SECOND AND THIRD READINGS SUMMARY SHEET

CASE: C814-89-0003.02 – 305 S. Congress

ADDRESS: 305 South Congress Avenue

From: [Rusthoven, Jerry](#)
To: [Rivera, Andrew](#); [Rhoades, Wendy](#)
Subject: Fwd: Q&A for Item 69
Date: Thursday, April 7, 2022 9:28:42 AM
Attachments: [image001.png](#)

Conceptual Open Space Map

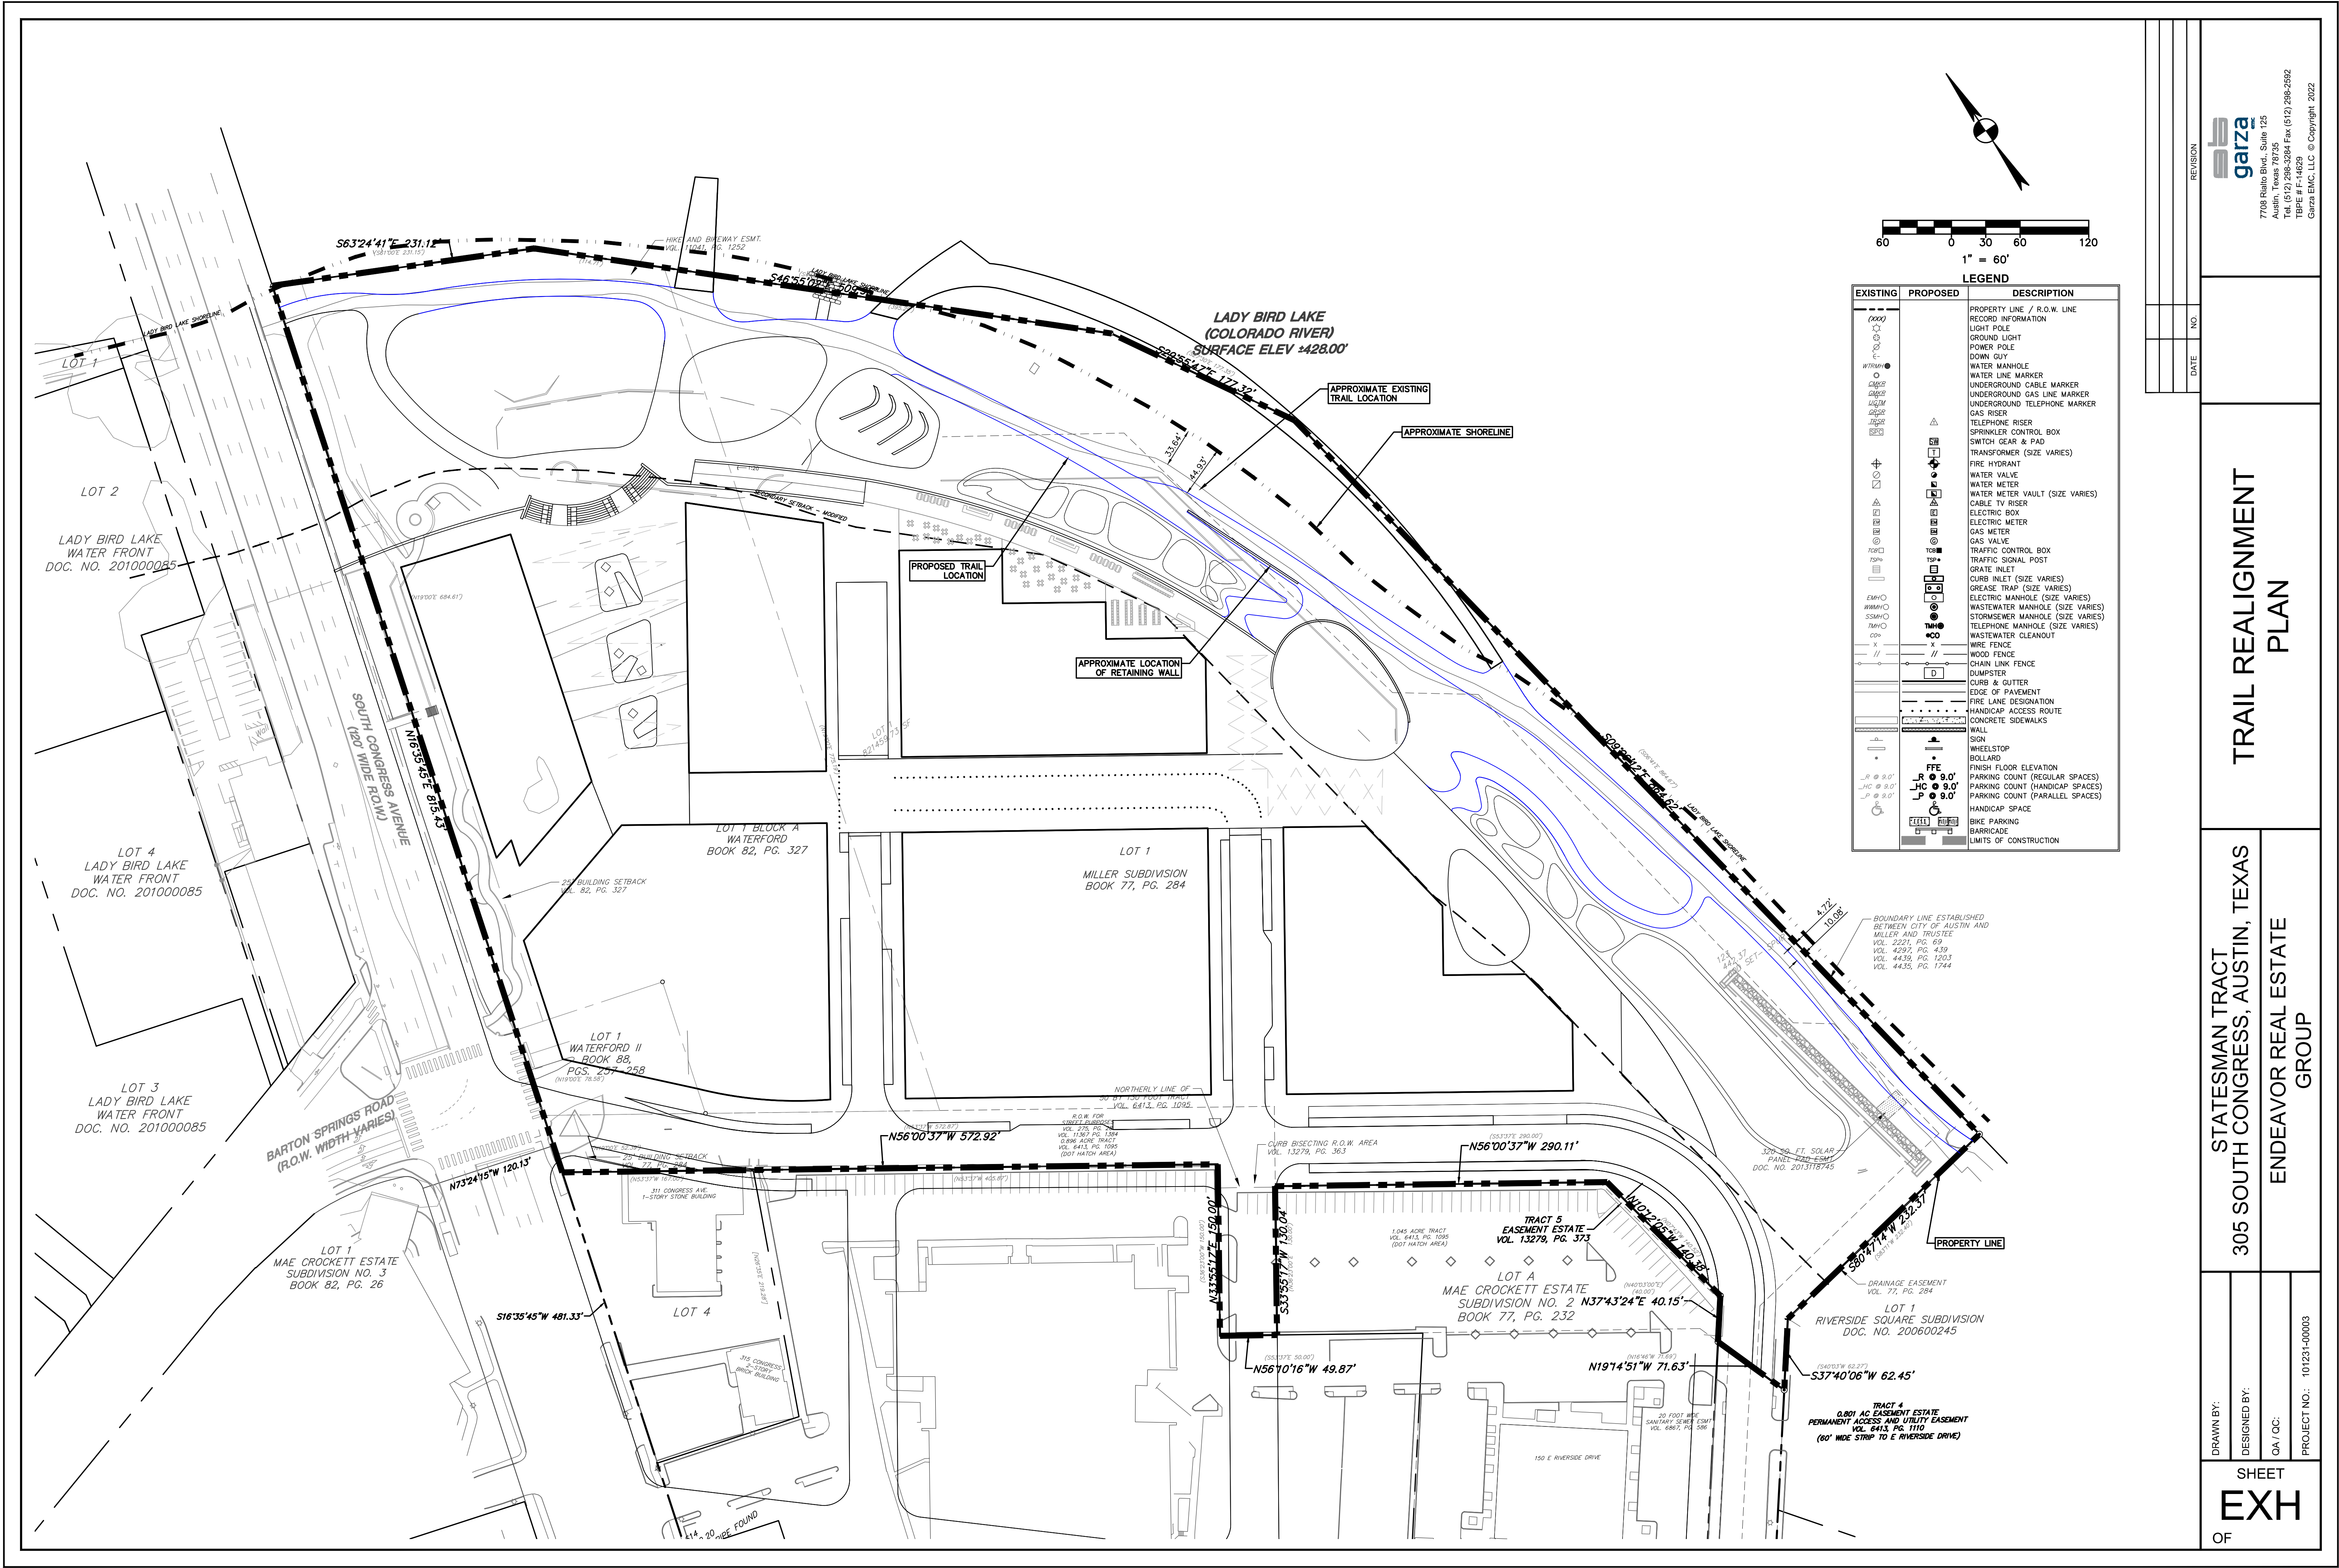
5. *What percentage of the proposed public amenities and parkland will be in the floodplain?*

RESPONSE: 62.3% of the fully dedicated parkland will be in the Floodplain and Critical Water

Quality Zone. See chart below for a full breakdown of percentages.
